LAUREL CREEK DAM

INVENTORY NUMBER NDS 578

PHASE I INSPECTION REPORT

NATIONAL DAM INSPECTION PROGRAM

Cracked Wall
At Spillway

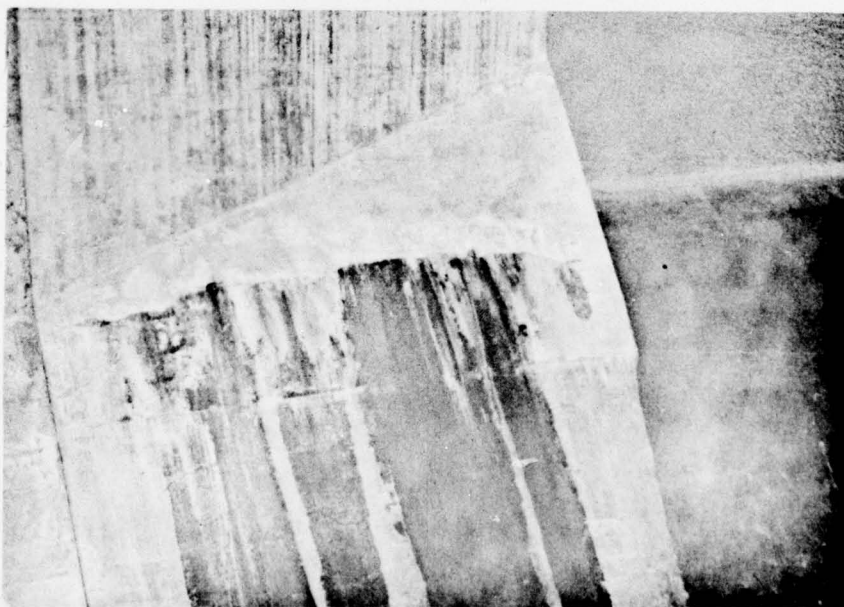
All appurtenant structures were in good condition. Besides some shrinkage cracking, a crack was noticed near the entrance of the spillway (Appendix D, Plate V). The manager stated that this crack will be pressure grouted during the summer (1978), when the pool level falls 3 or 4 feet below spillway crest. The cause of the crack could not be determined. Water over the spillway has not been high enough to cause any stresses in this wall. It could have been a cold joint with poor workmanship after the pour started.

1. The owner should install an outside staff gage on the control tower.
2. The owner should repair the crack in the wall near the spillway.

Indications are from representative of owner that when the reservoir gets below spillway level and the crack level repairs are going to be made. (7' to 8' normal drop below spillway during summer) has been as much as 14' below.
